UNITED STATES PATENT AND TRADEMARK OFFICE

Office Action Summary

10/596,271

DETAILED ACTION

With regard to claim 7, and as shown in Figure 5 below, Larkin et al disclose a connector for connecting to an end of a corrugated conduit, the corrugated conduit including a plurality of elevated corrugations, said connector defining perpendicular axial and radial directions and comprising:

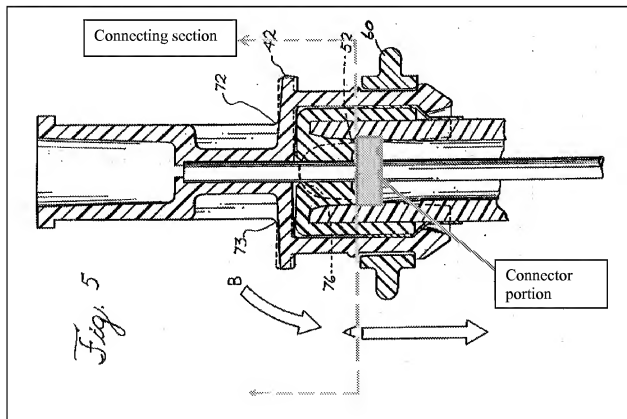
a clamp (62) extending from said connecting section and spaced radially from said first end of said connector portion, said clamp including an engaging nose (64) movable into a clamping position wherein said nose fits between two of the elevated corrugations of the corrugated conduit to thereby prevent the conduit from being separated from said connector;

an arresting depression (see Figure 5 - sliding bushing 60 located in arresting depression) provided in an end of said clamp distal from said connecting section, said arresting depression located radially adjacent said engaging nose; and

a sliding bushing (60) surrounding said connecting section, said sliding bushing movable between a release position in which said sliding bushing is disposed in said releasing depression and said engaging nose is movable into said clamping position, and a locking position in which said sliding bushing is disposed in said arresting depression and said engaging nose is prevented from moving out of said clamping position.

With regard to claim 11, Larkin et al in view of Dehar disclose said clamp comprising two clamping brackets disposed parallel to said longitudinal axis on respective opposite sides of said connector portion, one of said brackets including said engaging nose (see Figure 5).

With regard to claim 14, Larkin et al in view of Dehar disclose said sliding bushing (6) being closely received axially between a pair of boundary sides of said arresting depression (see Figure 5).
